Access Compliance Report

Public Rights-of-Way

(Curb Ramps)

Intersection ID: 30121	Main Street: CLOONEY_LN	Cross Street: VERNON_WOOD_LN	Location: NE
ADA ID: 8DB0A1A58A8E	Ramp Type: Perpendicular Diagonal	Initial Pass/Fail: Fail	Overall Compliance: No
Severity Score: 21.25			
Codes/Mitigation Info/Possible Solution		Field Measurements/Component Compliance

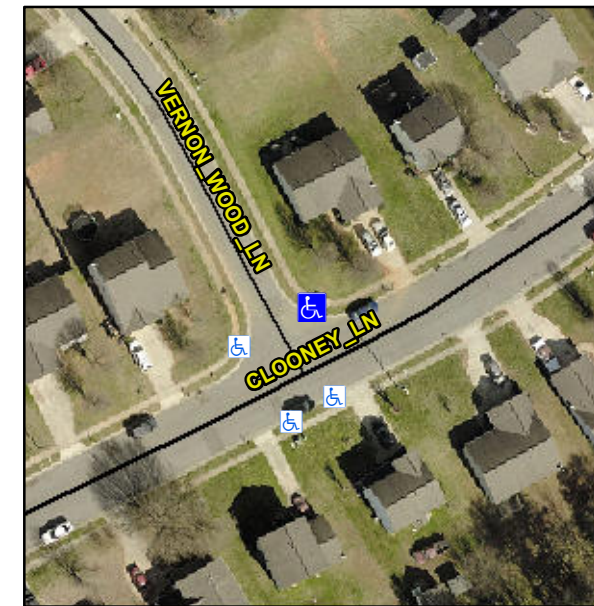
Not Found, R304.5.1, R304.5.3

Compliance	Description	Data	Compliance	Description	Data
N/A	Ramp Length (in)	50.0	Yes	Ramp Slope (%)	6.2
No	Ramp Width (in)	42.5	No	Ramp XSlope (%)	5.7
N/A	Flare Type LT	N/A	N/A	Flare Type RT	N/A
N/A	Flare Slope LT (%)	N/A	N/A	Flare Slope RT (%)	N/A
N/A	Flare Traversable LT?	N/A	N/A	Flare Traversable RT?	N/A
N/A	Landing Length (in)	N/A	N/A	DWS Provided?	N/A
N/A	Landing Width (in)	N/A	N/A	DWS Contrast?	N/A
N/A	Landing Slope (%)	N/A	N/A	DWS Length (in)	N/A
N/A	Landing X Slope (%)	N/A	N/A	DWS Full Width?	N/A
N/A	Landing Curb? (Y/N)	N/A	N/A	DWS Offset (in)	N/A
N/A	Shared Landing?	N/A			
N/A	Gutter Ponding?	N/A	N/A	Gutter Slope (%)	N/A
N/A	Gutter Lip Ht (in)	N/A	N/A	Gutter X Slope (%)	N/A
N/A	Painted X Walk1?	No	N/A	Painted X Walk2?	No
	X Walk 1 Direction	To W		X Walk 2 Direction	To S
N/A	X Walk 1 Width (in)	N/A	N/A	X Walk 2 Width (in)	N/A
	X Walk 1 Slope (%)	3.3		X Walk 2 Slope (%)	1.4
	X Walk 1 X Slope (%)	2.8		X Walk 2 X Slope (%)	2.3

Remove & Replace Curb Ramp With Two New Directional Ramps or Equivalent.
